PROJECT S 1st and St Helens Intersection Improvements
CONTRACTOR Moore Excavation Inc.
PROJECT WALK-THROUGH May 29th, 2025

PROJECT NO. R-685
DATE May 30th, 2025

PROJECT PUNCH LIST

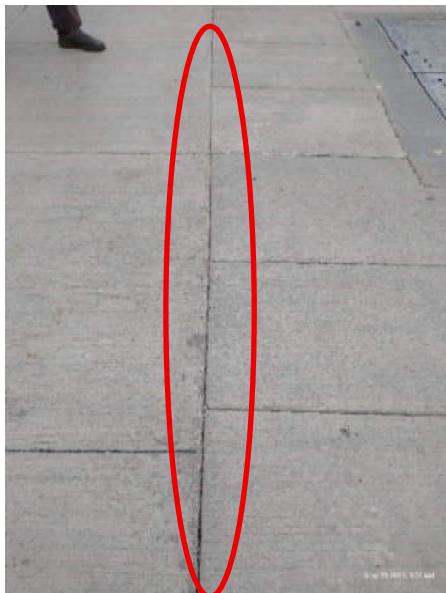
- ❑ Repair damage to precast cap for Planter D and Planter A. Sheet L4.01.

- ❑ Repair damage to precast cap edge for Planter A. Sheet L4.02.

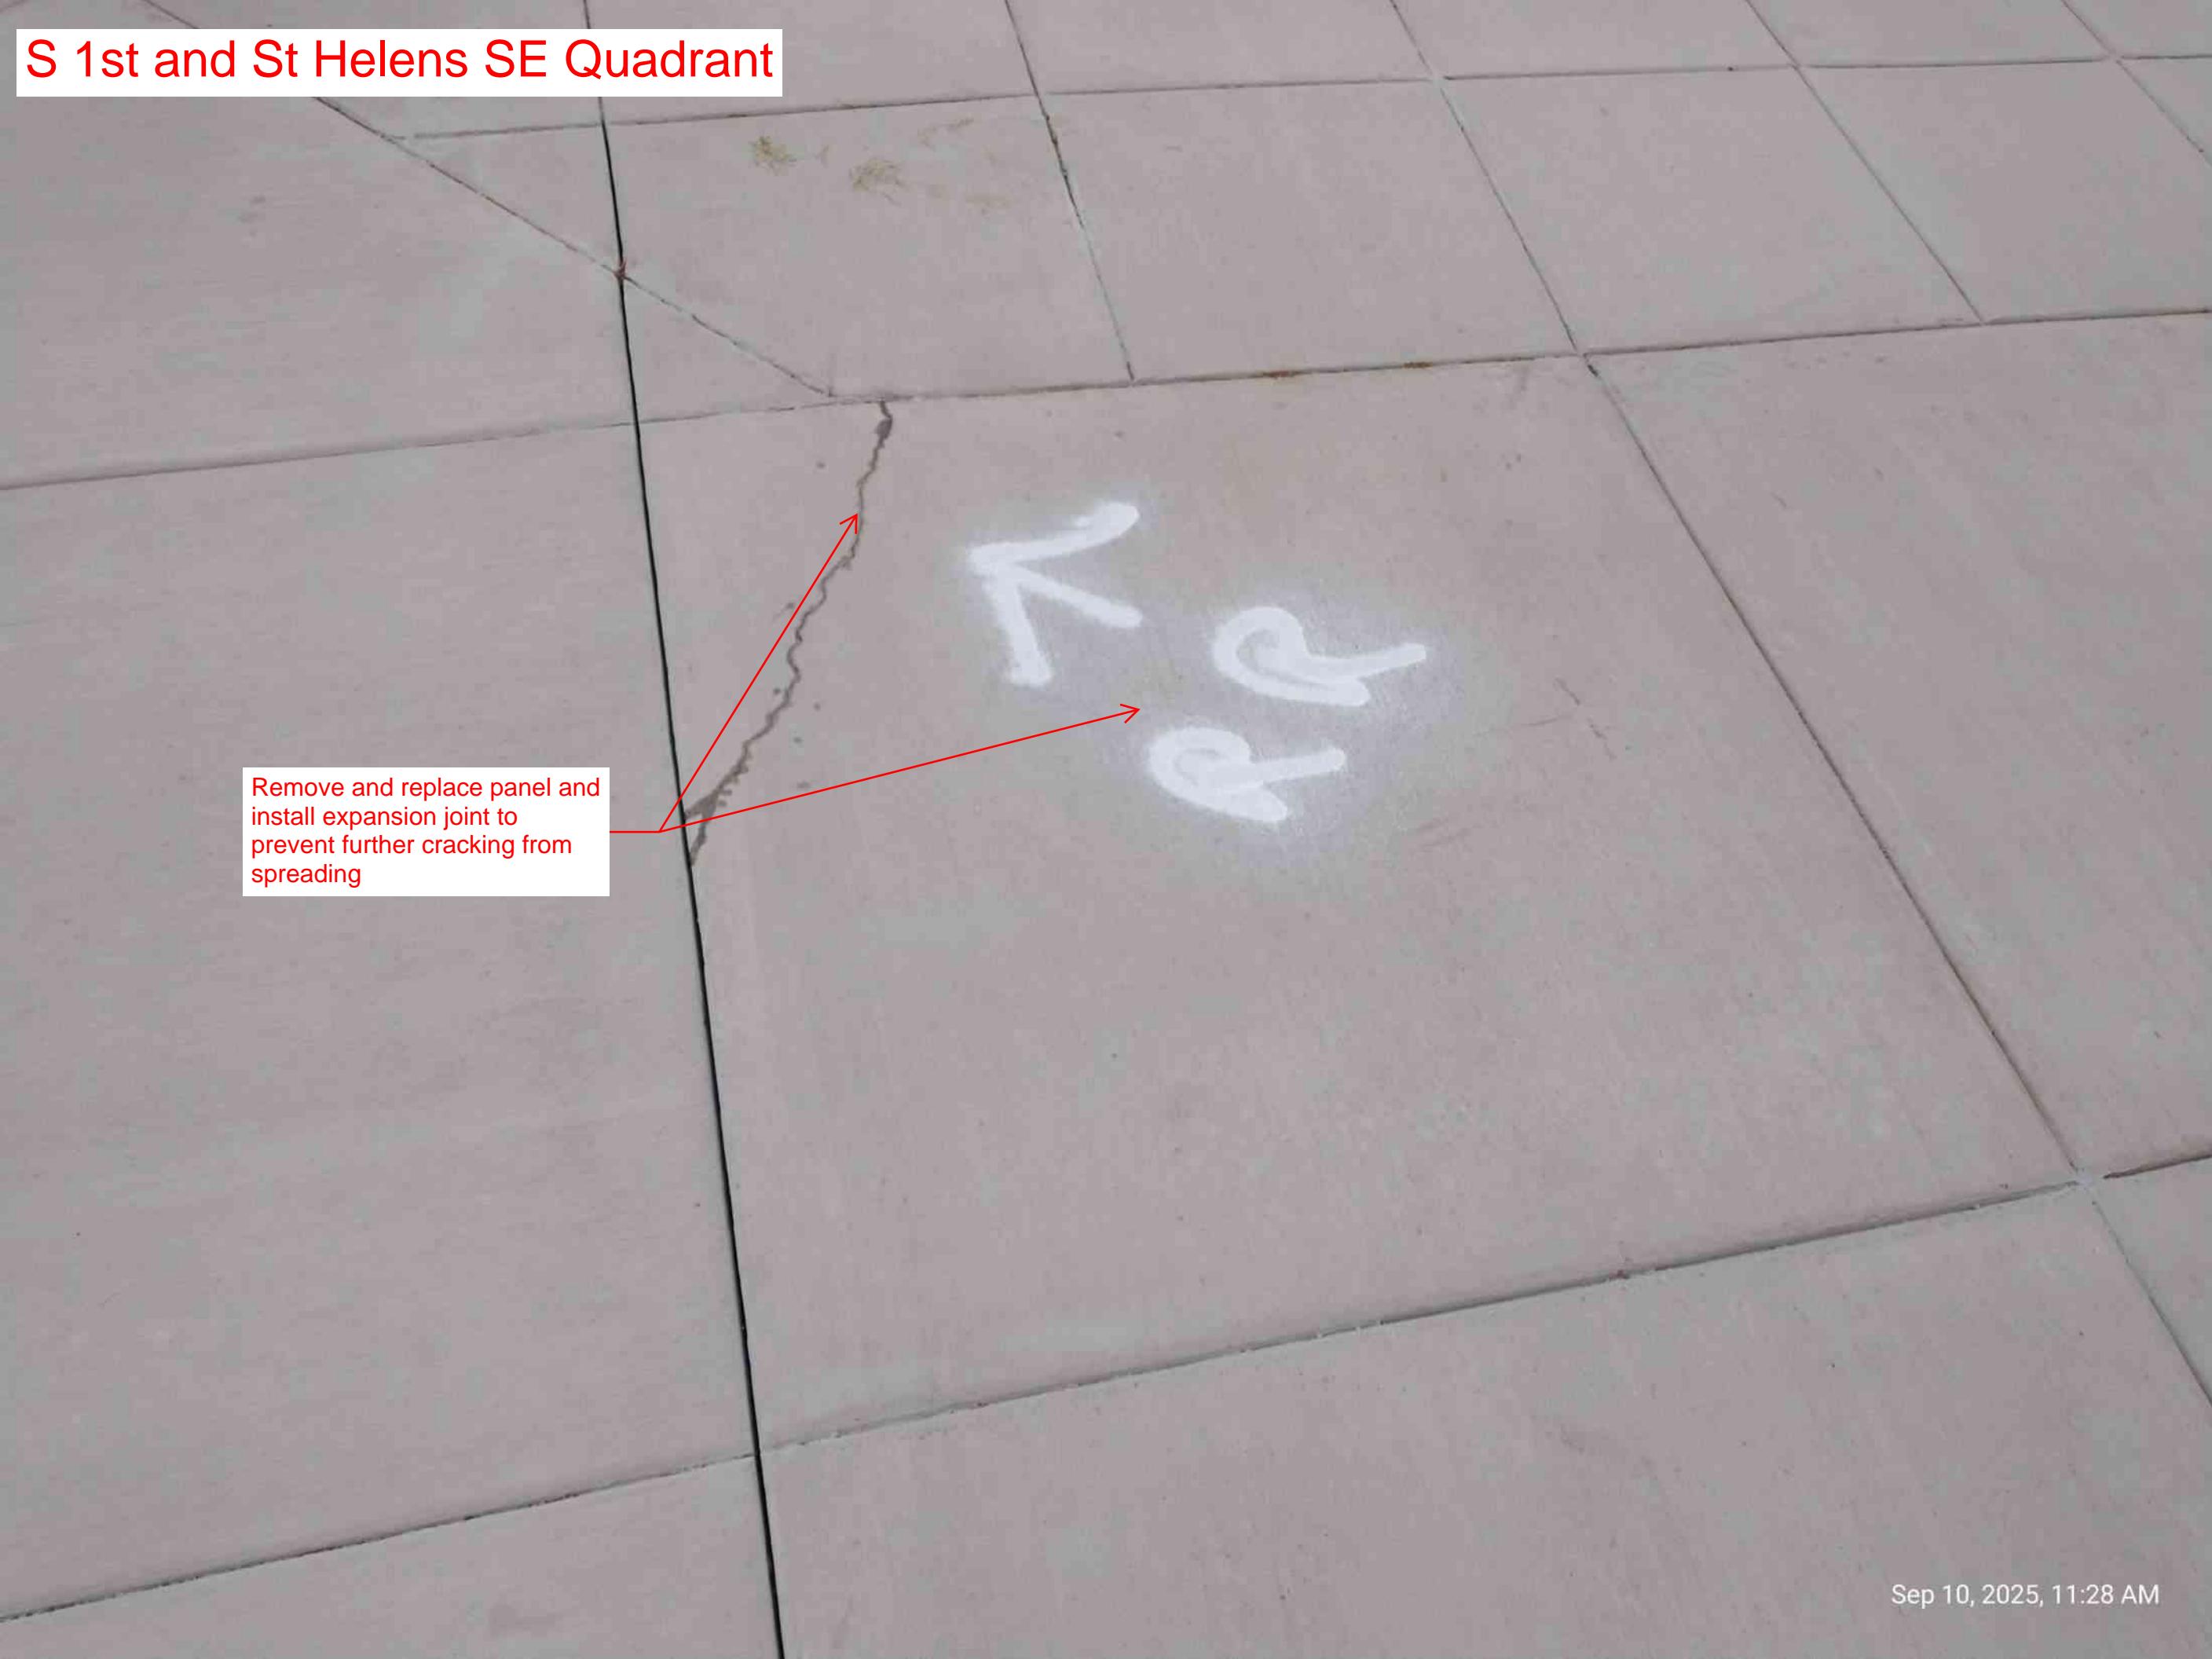
Planter E – the wide grout joint shown below is well outside the specified width range, reference 00596C.44-e.

S 1st and St Helens NW Quadrant

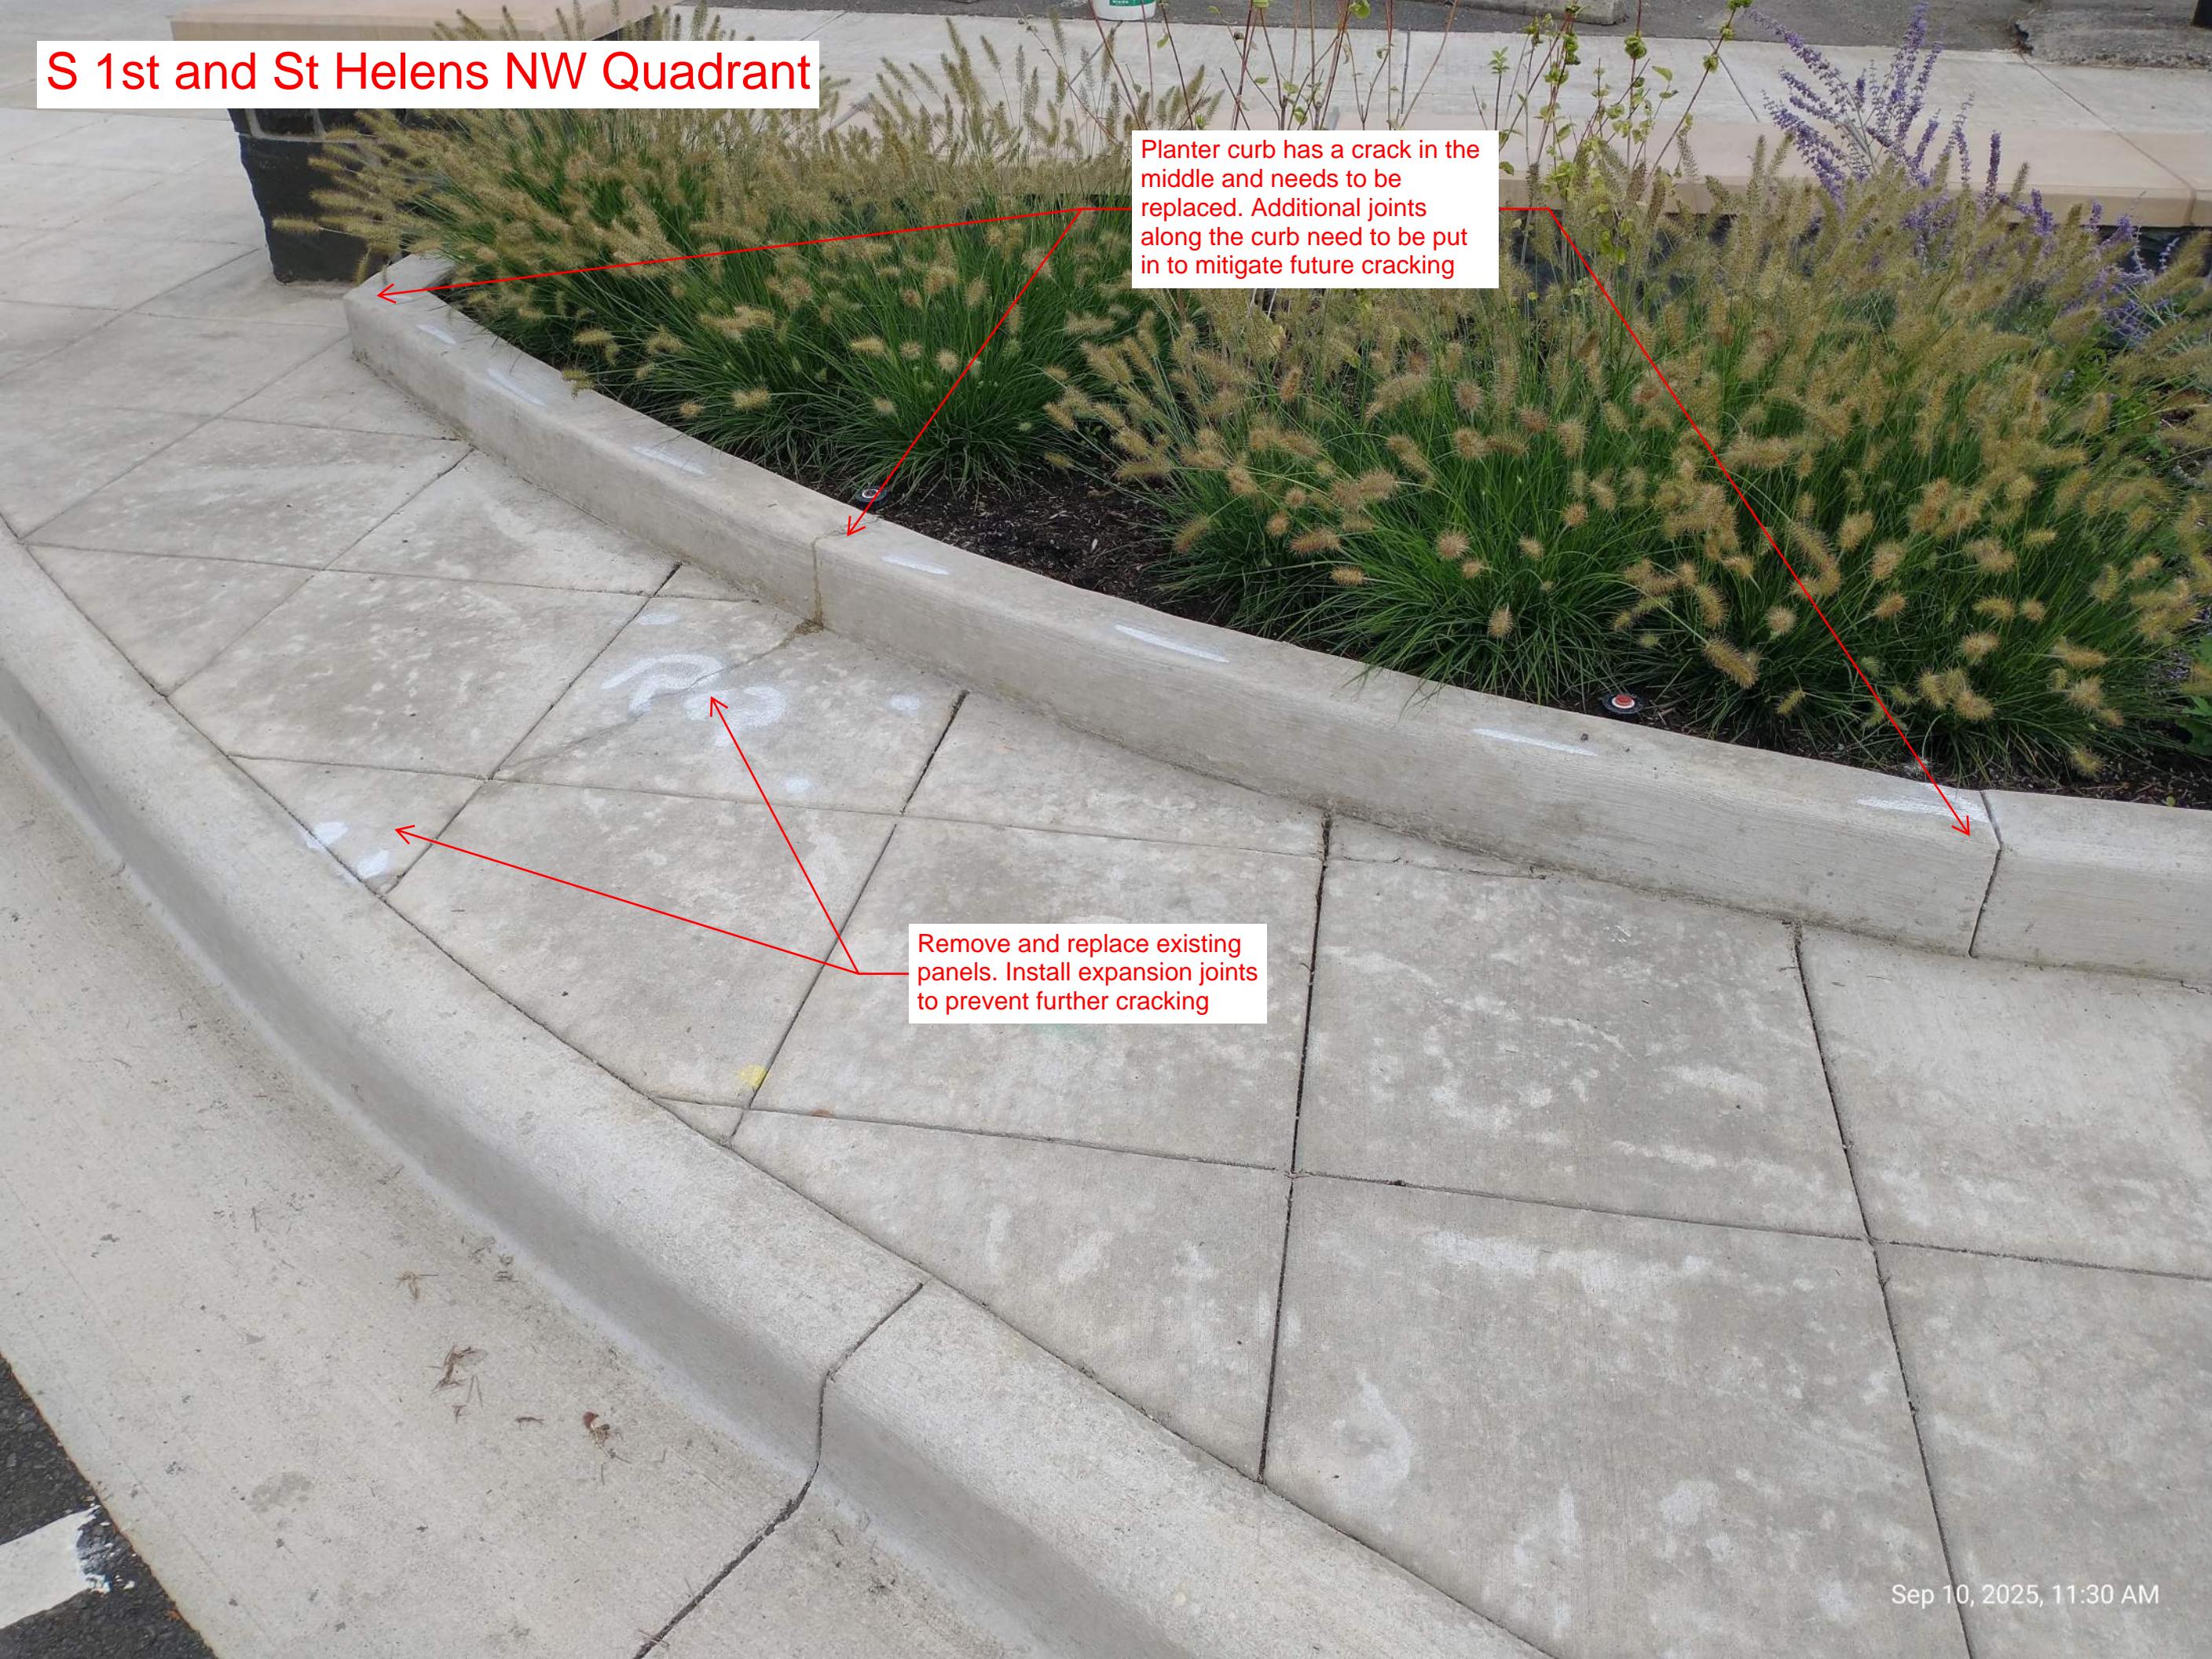
Remove and replace panels and install expansion joint around communication box to prevent further cracking from spreading. Comms box needs to be adjusted to be flush with finished grade
